Editorial Impact of Multiple Families / PCS / PMAs

Supporting Material – Comments #65 & 66

John D'Ambrosia, Futurewei, U.S. Subsidiary of Huawei

23 May 2023

Figure 116-1—Architectural positioning of 200 Gigabit and 400 Gigabit Ethernet

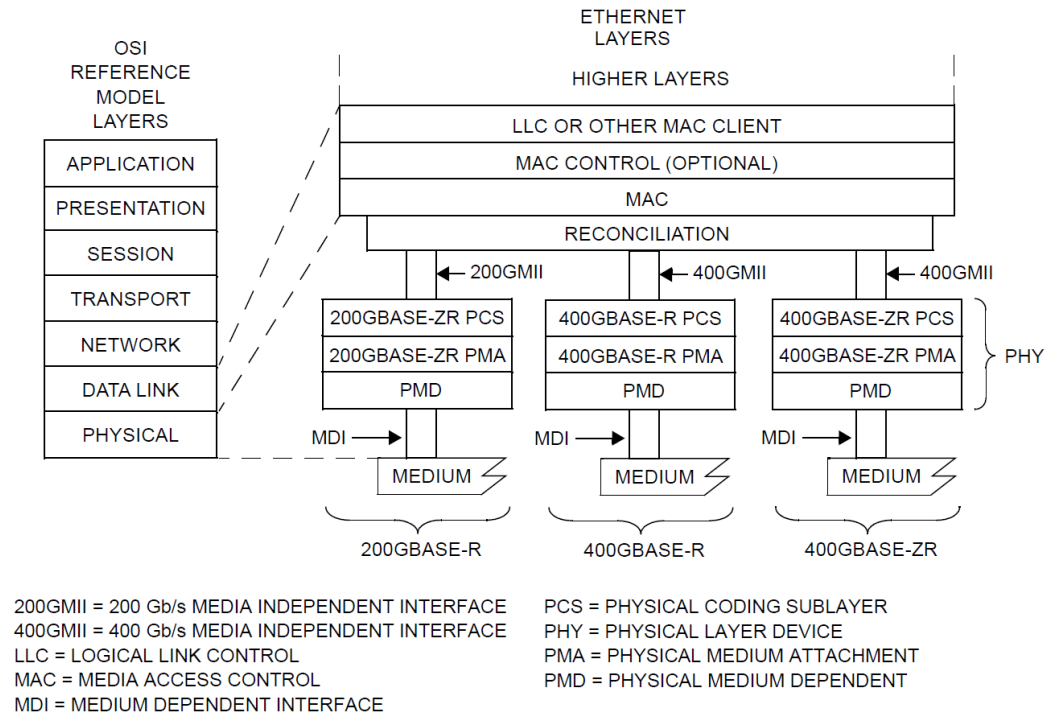
- During IEEE P802.3cw it was noted that **400GBASE-ZR is not part of the 400GBASE-R family**
 - **Different PCS (Clause 155) than 400GBASE-R (Clause 119)**
- As part of IEEE P802.3cw (D2.1) **400GBASE-ZR has now been separated from 400GBASE-R**
- This has taken a lot of effort to retro-fit in the existing IEEE 802.3 standard
- We should strive to avoid creating this issue for the future IEEE 802.3 standard and future 800 GbE / 1.6 TbE amendments to have to address
- **Comment #65 Suggested remedy –**
 - **Change all instances in text and figures of PCS and PMA in the document that are relevant to 400GBASE-R PMDs to "400GBASE-R PCS" and "400GBASE-R PMA"**
